Subject: Amended Agreement to Build Northpark at Montrose

**MPDU AMENDED AGREEMENT TO BUILD  
SUMMARY COVER SHEET**

Name of Development: Northpark at Montrose

**AMENDMENT TO AGREEMENT TO BUILD MODERATELY PRICED DWELLING  
UNITS FOR A PERMIT OF 20 OR MORE DWELLING UNITS**

**LOWER LEVEL PLANS**

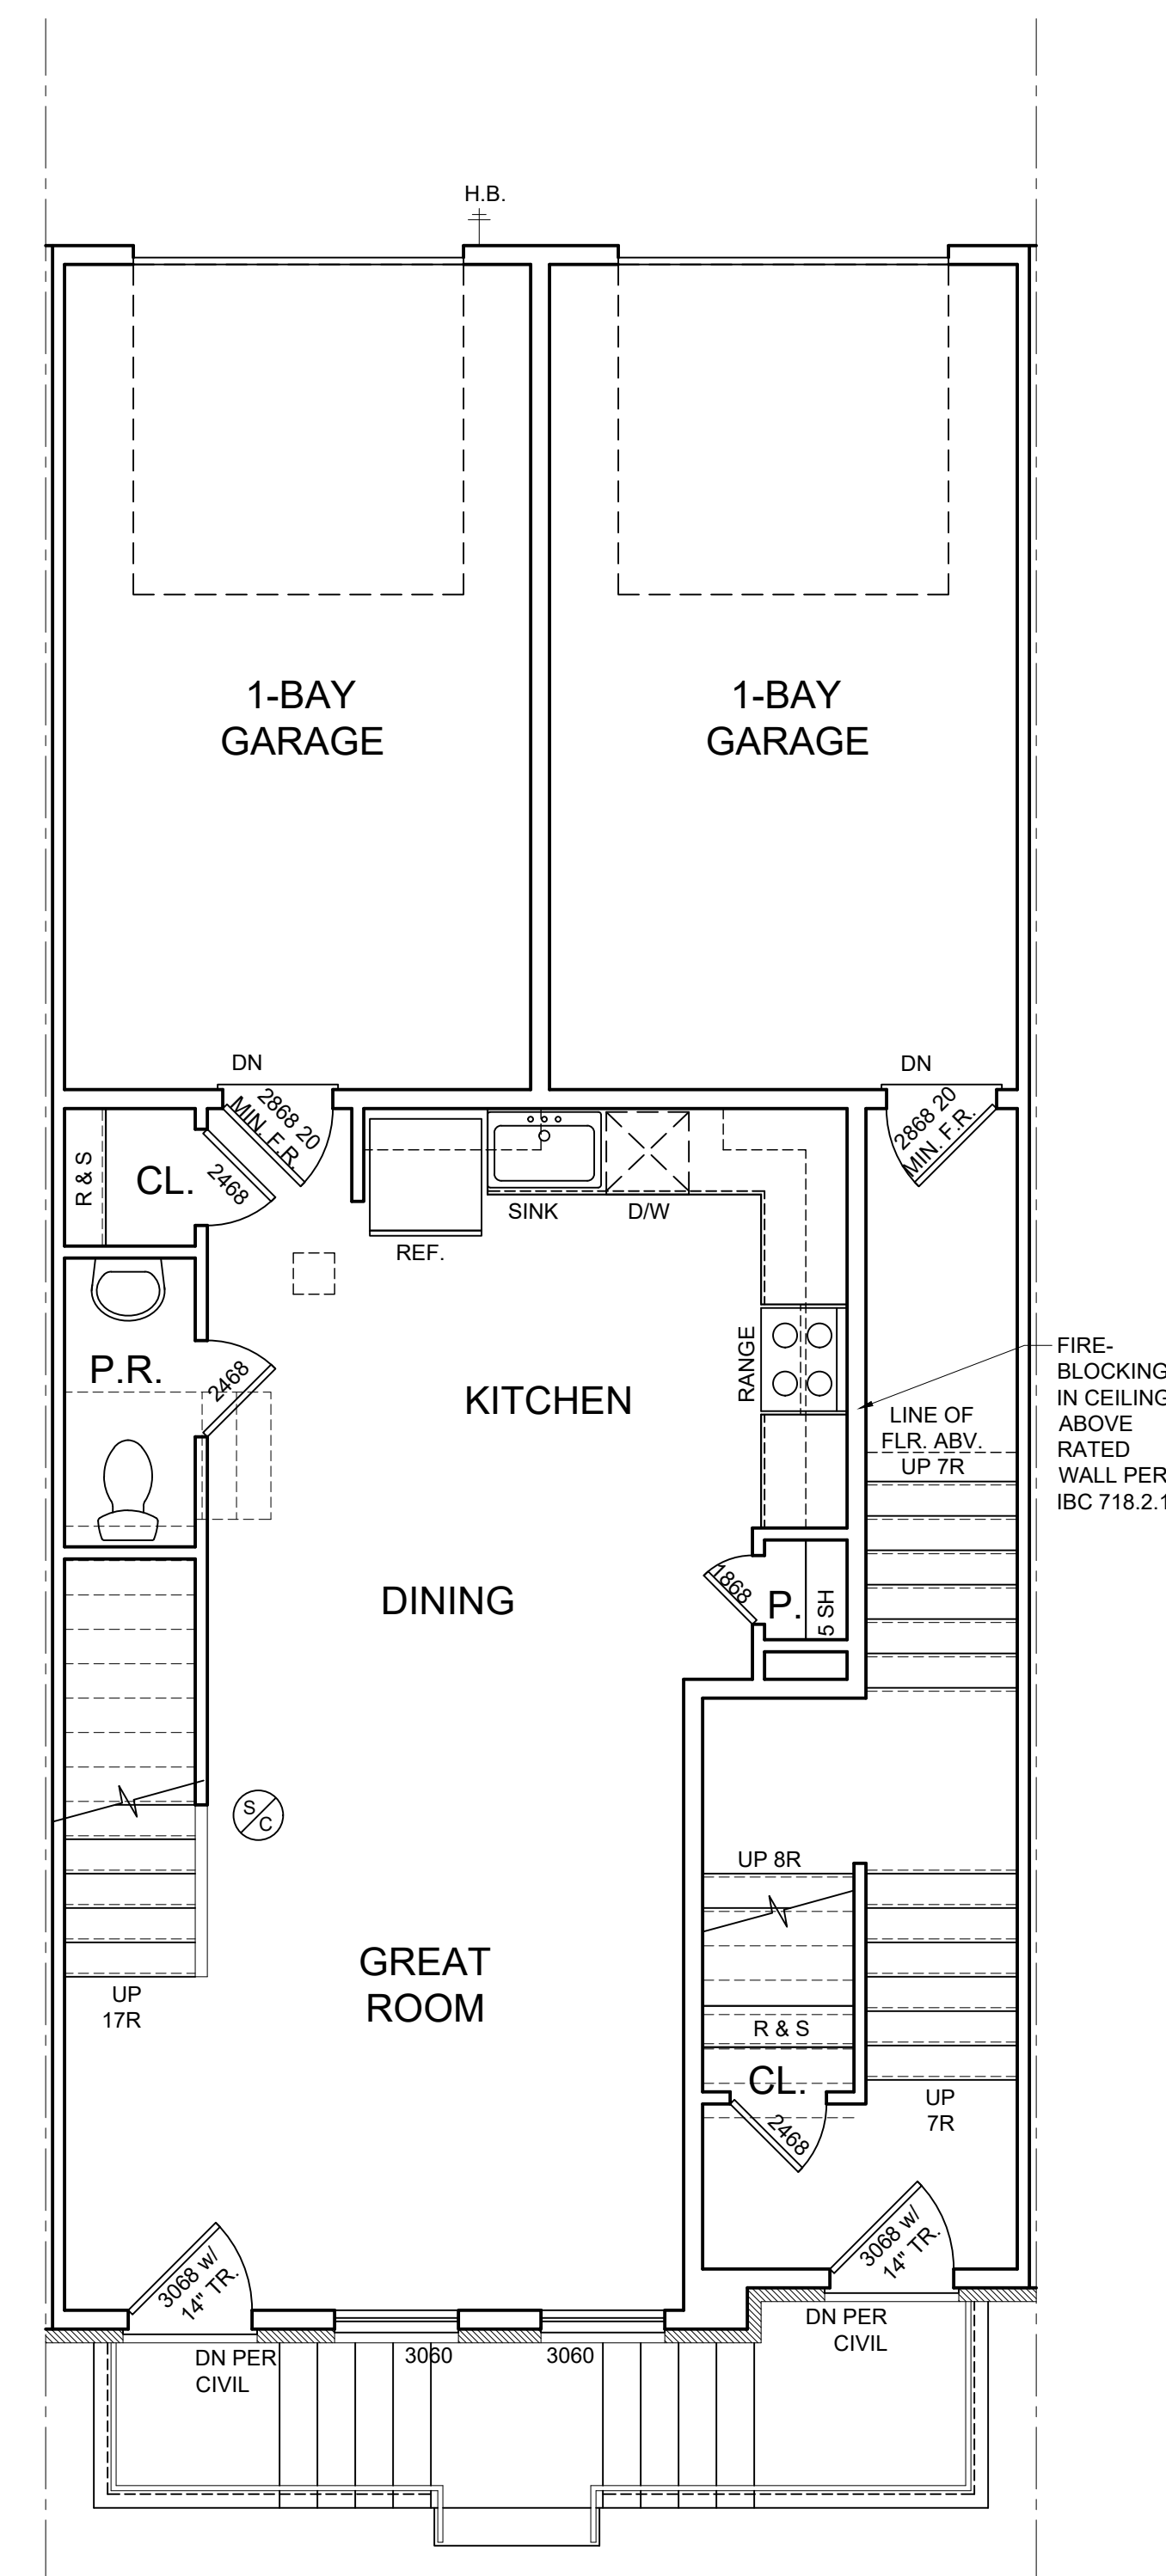
**WHEREAS**, **Exhibit F** to the Agreement provides floor plans for the MPDUs and Applicant wishes to provide floor plans for “Two over Two” MPDUs constructed in the “reversed” interior condition.

1. **Exhibit C** shall be amended to reflect the correct addresses as shown on **Exhibit C** attached hereto.
2. **Exhibit D** the Declaration of Covenants Exhibit 1 shall be amended to reflect the correct addresses. The remainder of the Declaration of Covenants shall remain unchanged from the original Agreement.
3. **Exhibit F** shall be amended to include floor plans for the “Two over Two” MPDUs constructed in the “reversed” interior condition.
